**PG&E KERN DIVISION
ELECTRIC DISTRIBUTION AUDIT FINDINGS
NOVEMBER 18-22, 2024**

Figure 2: Guy slack limit, TD-2305M-JA02

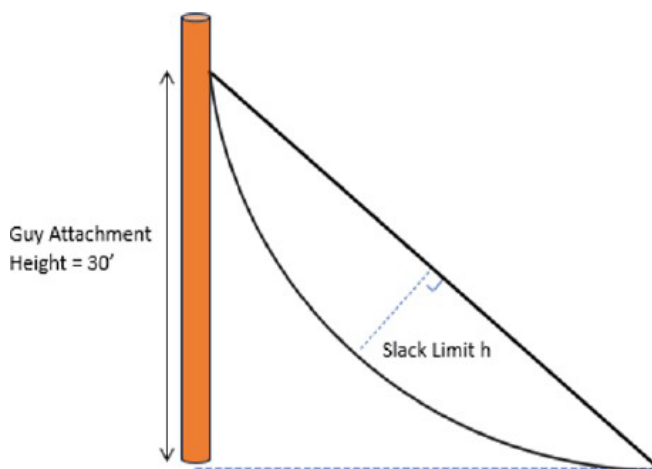
PG&E’s TD-2305M-JA02, Job Aid: Overhead Assessment, March 25, 2024 Rev. 13, Miscellaneous Other Compelling Abnormal Conditions, Guy Broken/Slack/Corroded states, *“Pole must be straight with Guy no more than an arm’s length (3ft) from taut, that does not have significant impact on the structural integrity of the pole.”* See Figure 2.

Per GO 95, Rule 56.2, guys are to be maintained taut.²⁶ PG&E’s TD-2305M-JA02 allows a deviation from taut by as much as 3 feet without regard to length or angle of attachment.²⁷
